**Addendum Number 03  
(June 19, 2024)**

**EDINBURG CTE CENTER**

PBK Project No.: 20217

**ECISD Barrientes – Edinburg CTE Center  
Addendum #3**

S-403  
 PARTIAL ROOF FRAMING PLAN - AREA C  
 FOR BLUEBEAM LABELING OOR  
 File Path: Autodesk Docs:\Edinburg CSD\_20217\_Barrimentes CTE\20215 ECISD Barrimentes MS - CTE Renovations - R2 - Central\_vacillor.rvt  
 CHECKED BY: CC  
 DRAWN BY: VDV  
 Plot Stamp: 6/19/2024 4:24:00 PM

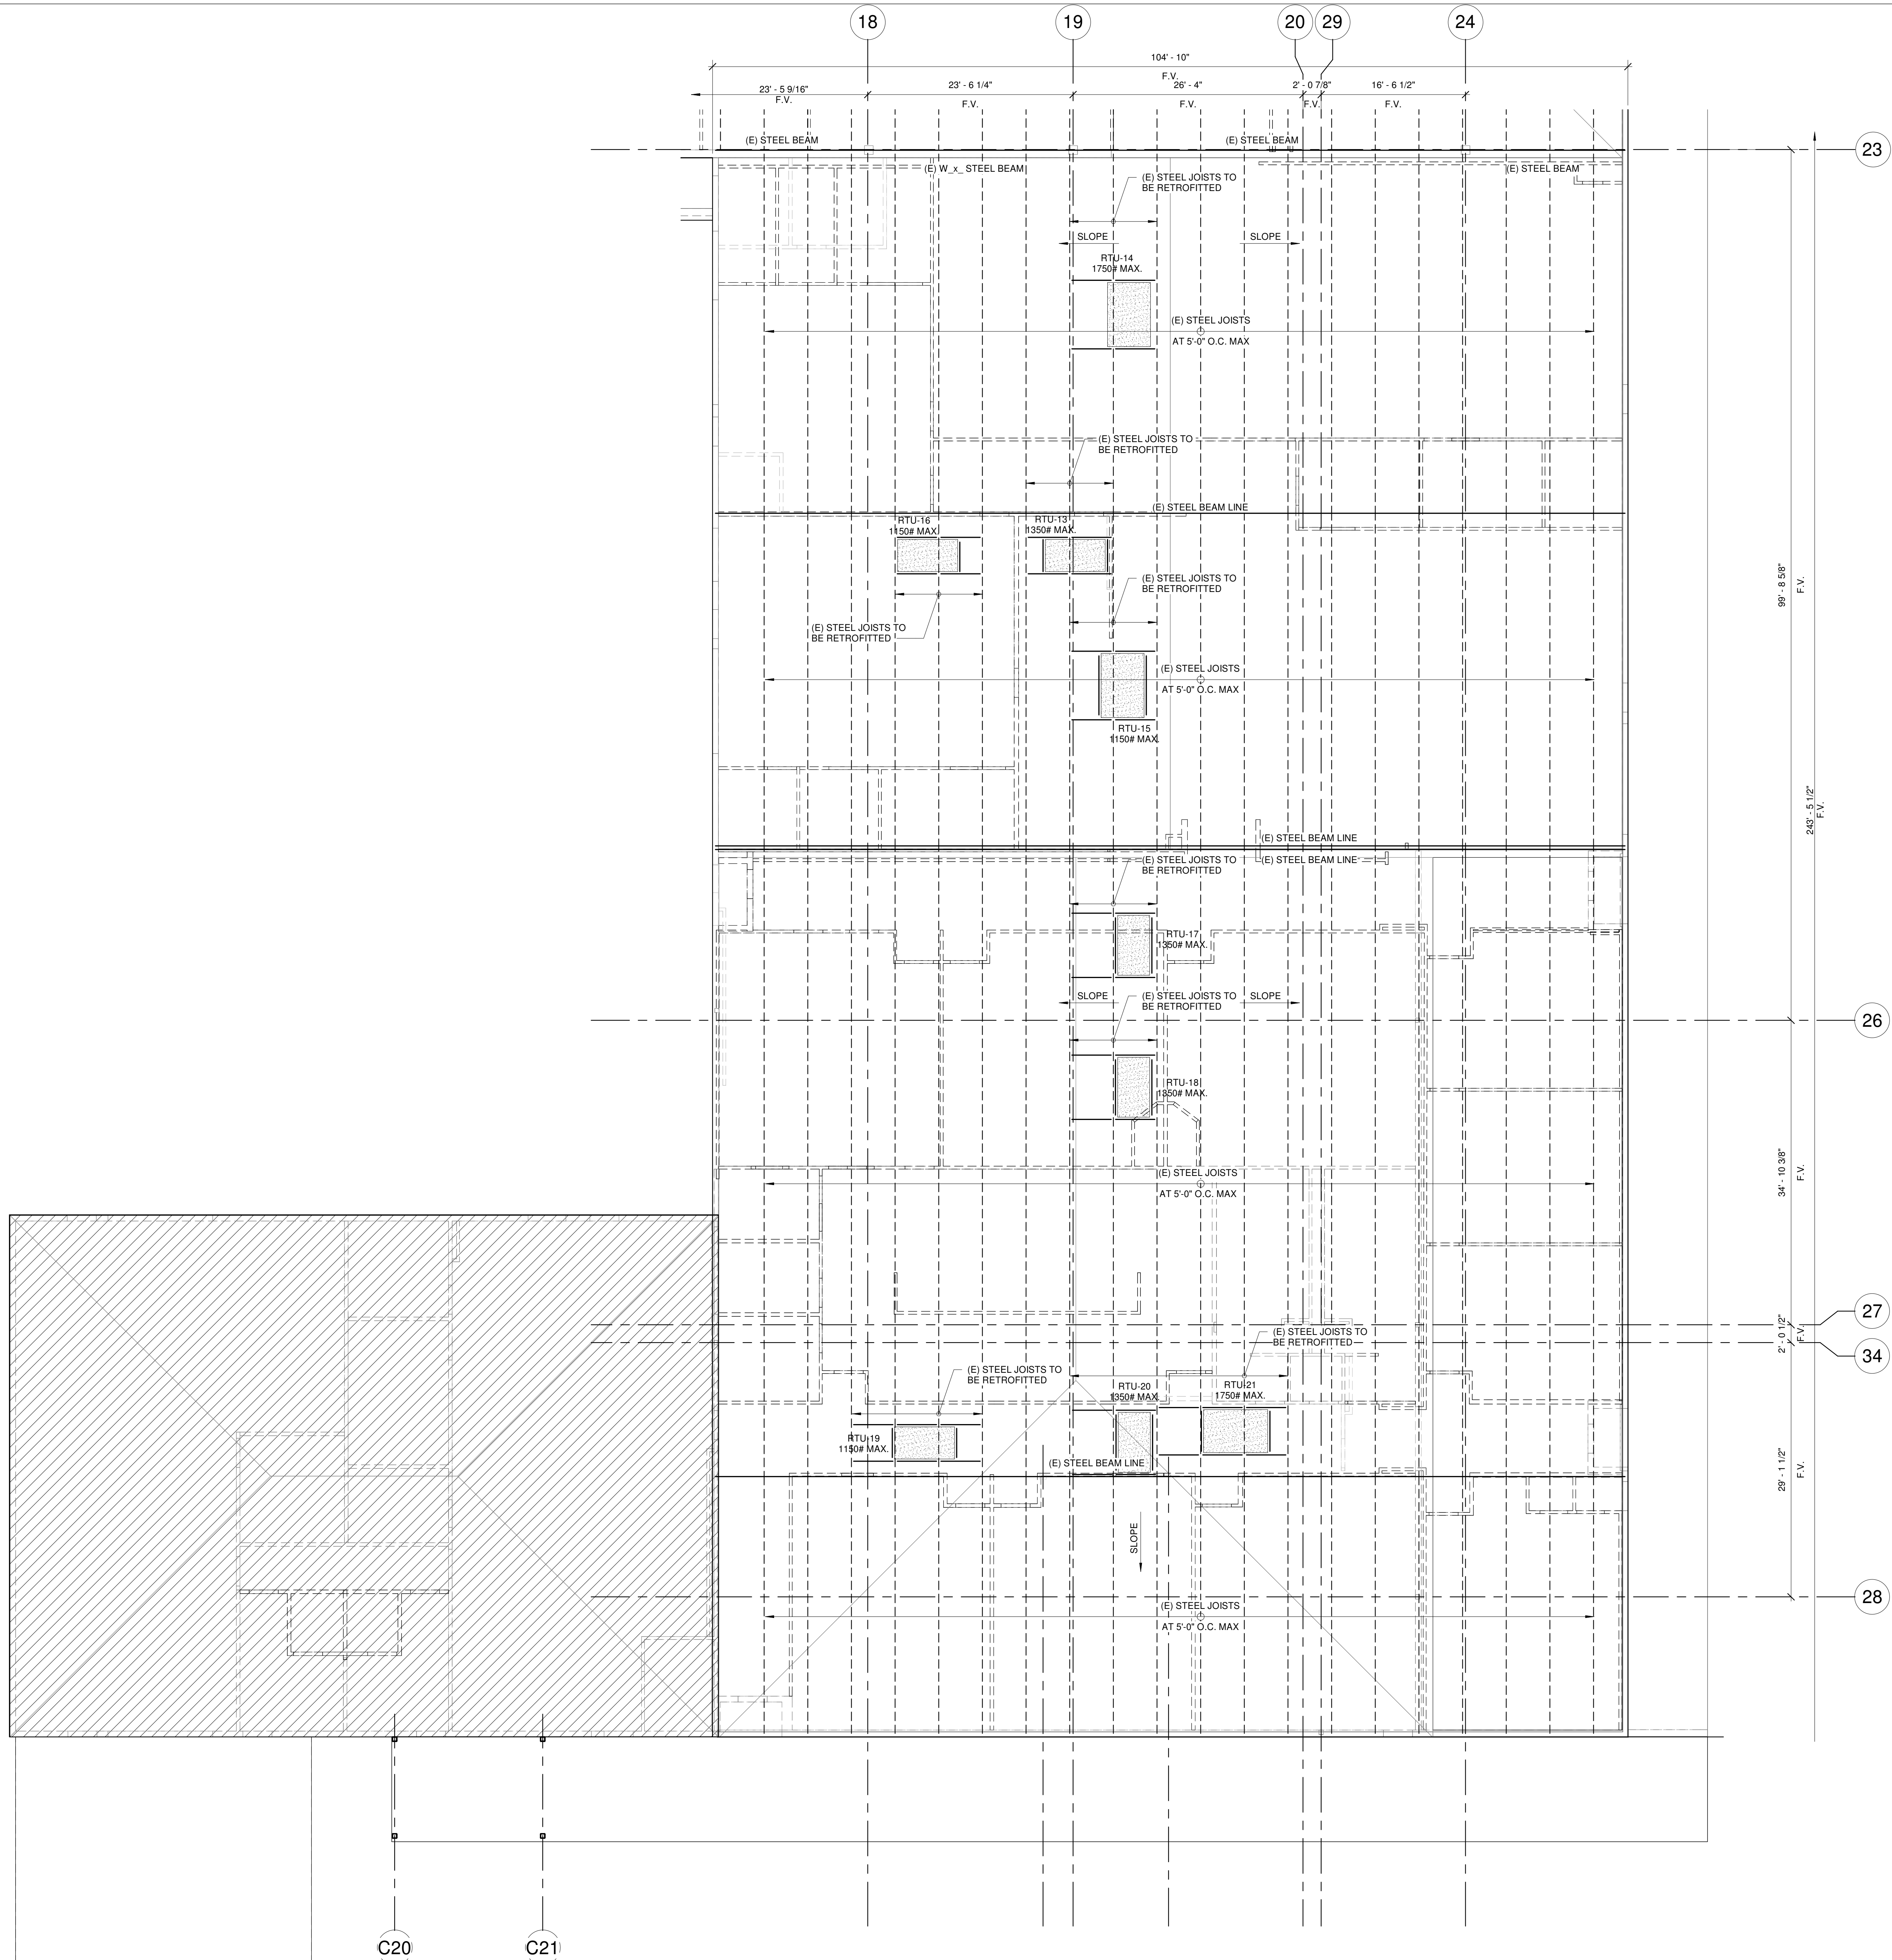
| 017 | S-403 – Partial New Foundation Plan – Area C   | Updated locations of mechanical roof top units. Delete in its entirety. Replace with revised Sheet S-403. Refer to attached.   |             |

**C2**

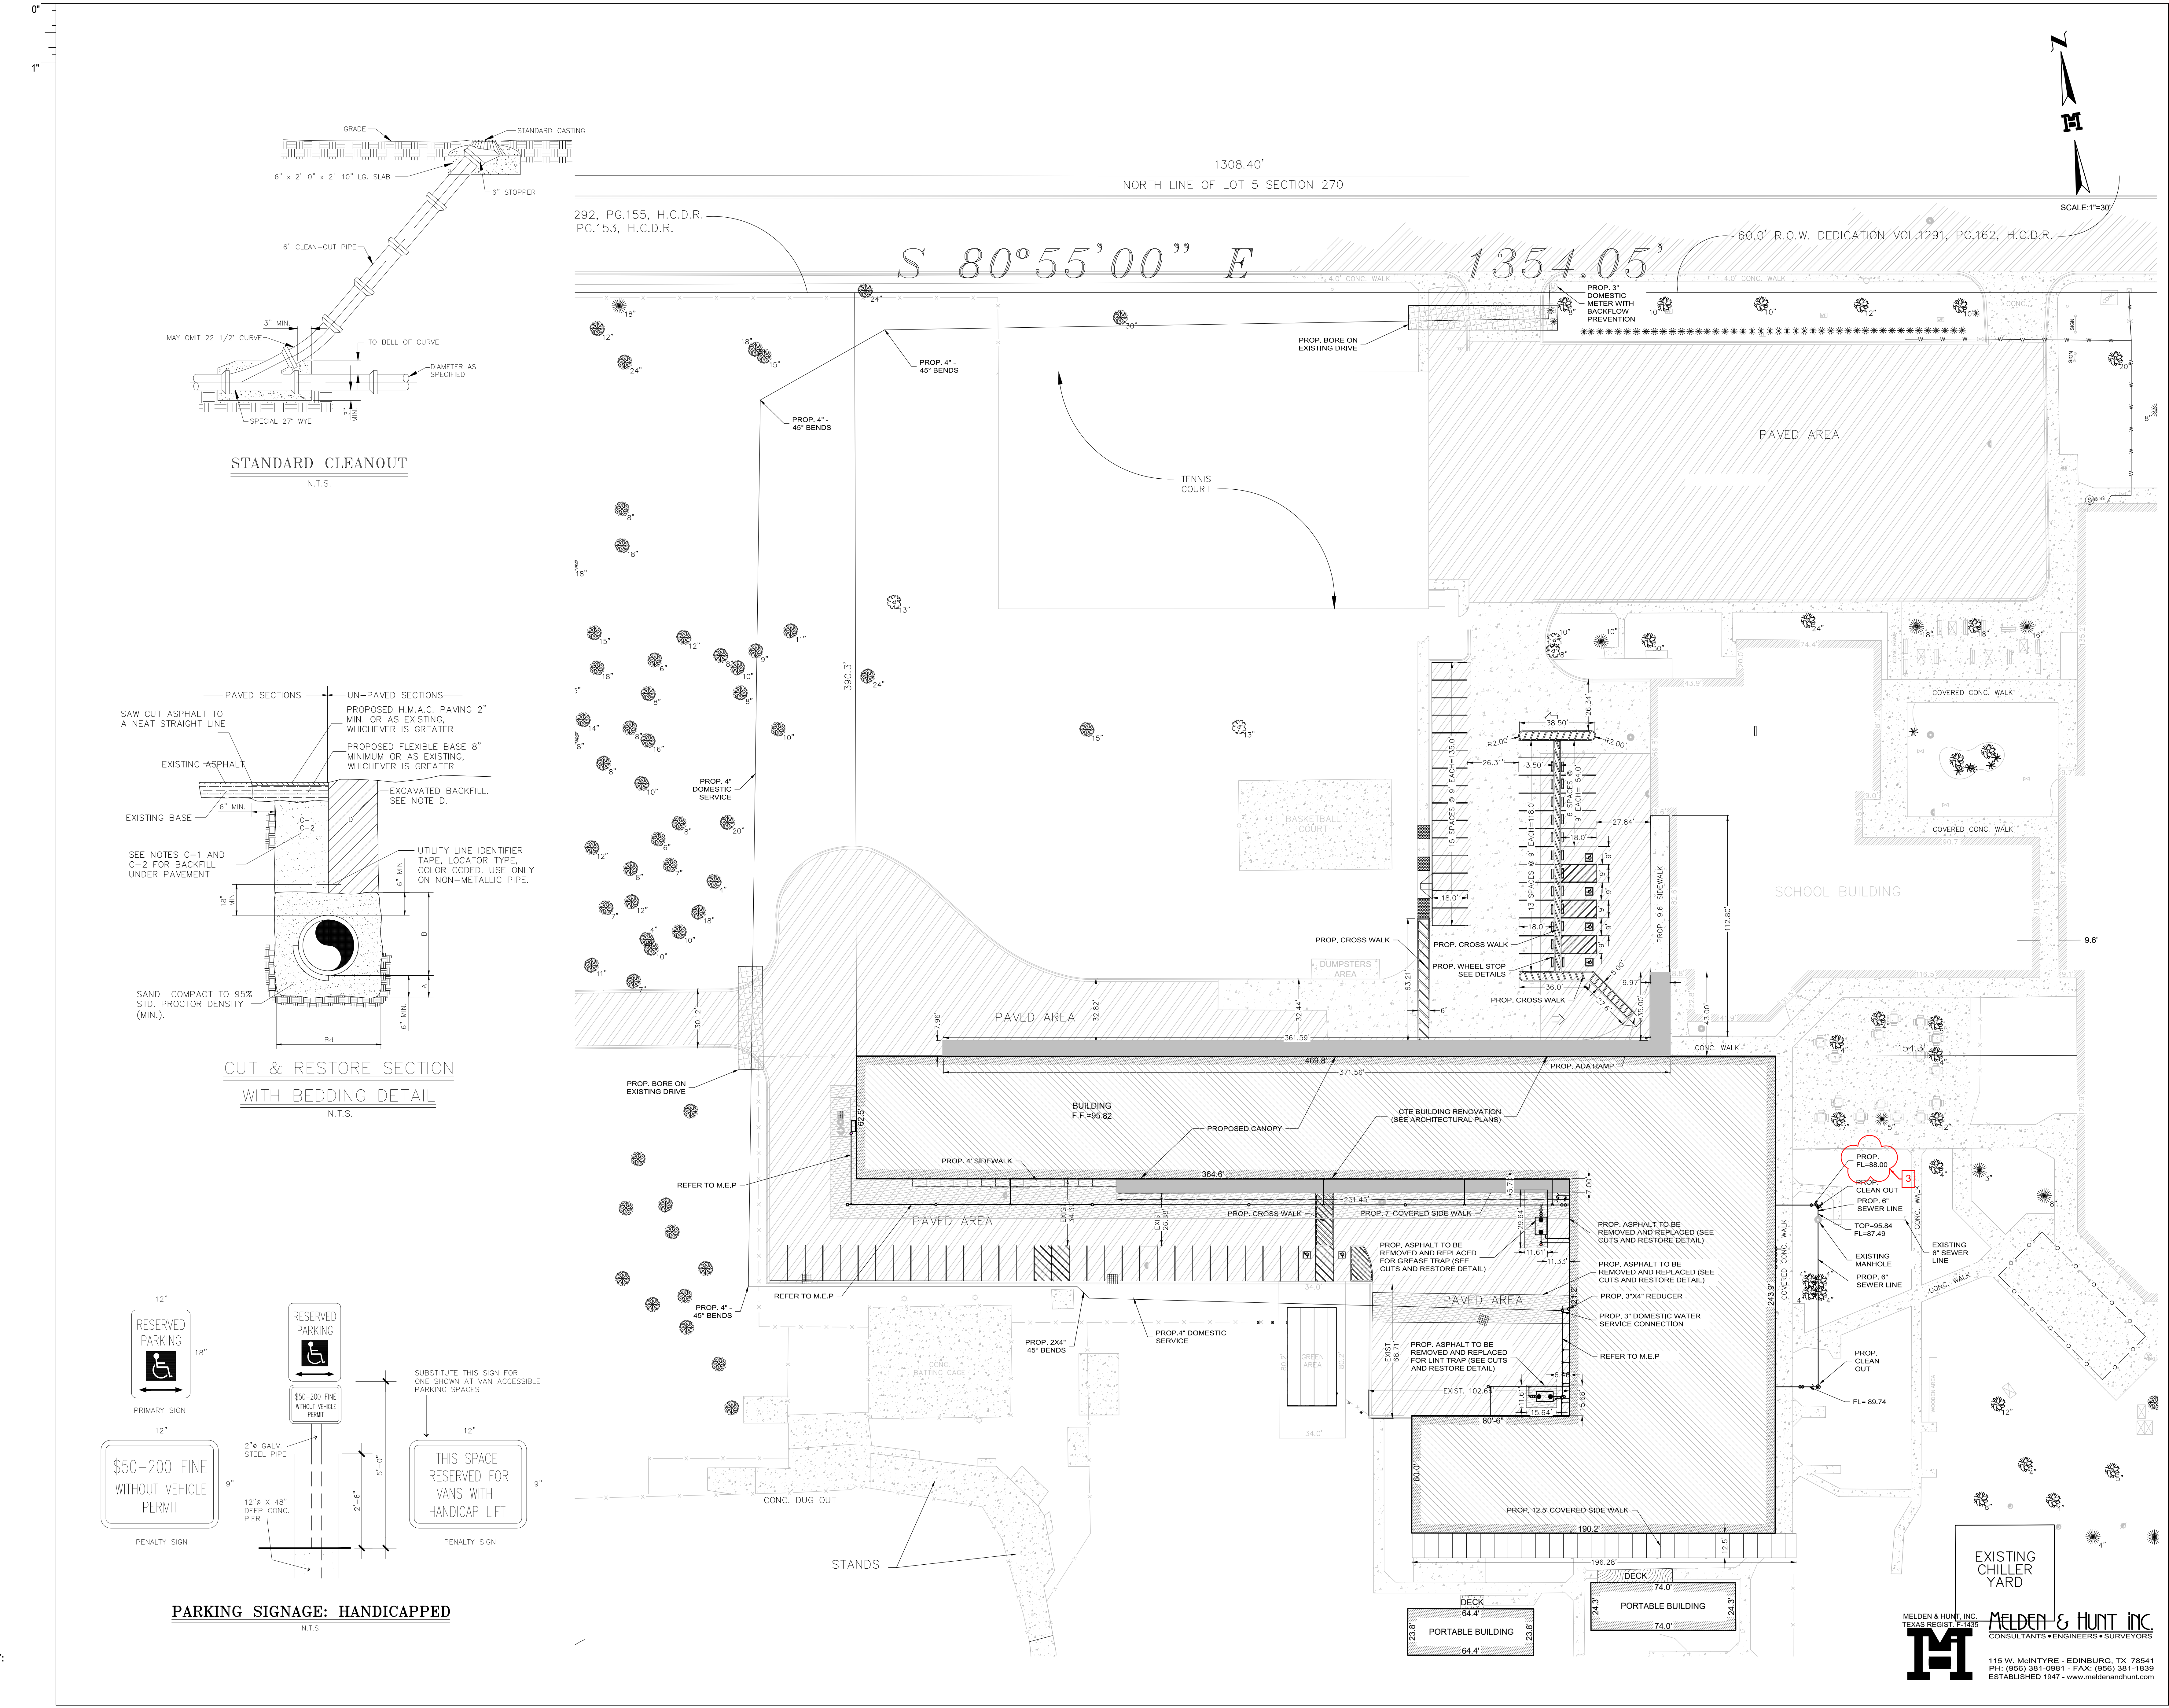
| 018 | Civil Sheet: C2  | Revised FL= 88.00  |             |
